Detailed Site Plan Alternative Compliance Amber Ridge

**DSP-19040
AC-20006**

SUBJECT: Detailed Site Plan DSP-19040
 Alternative Compliance AC-20006
 Type 2 Tree Conservation Plan TCP2-018-2018-01
 Amber Ridge

Figure 3: Proposed Freestanding Sign

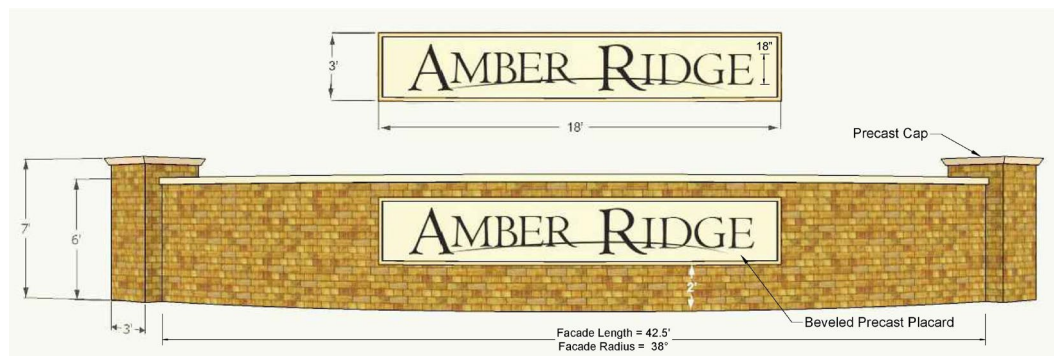
The DSP proposes one freestanding monument sign at the entrance to the development. The monument sign is approximately 5 feet high and 42 feet wide. The sign is brick and includes 7-foot-high columns on each end with a central concrete plaque for the community's name. The sign is externally illuminated using up-lighting. The sign appears to be generally acceptable, and landscaping is proposed behind the sign, but it is noted that attractive year-round landscaping has not been proposed at the base of the sign. Staff recommends that it be included to enhance the proposed signage, as conditioned herein. In addition, staff notes that a schedule has not been provided listing the square footage of the proposed sign. Therefore, a condition has been included in the Recommendation section of this report requiring that a signage area schedule be provided.

- b. Provide attractive year-round landscaping at the base of the gateway sign.
 - c. Provide a schedule clearly indicating the area of the proposed entrance sign.
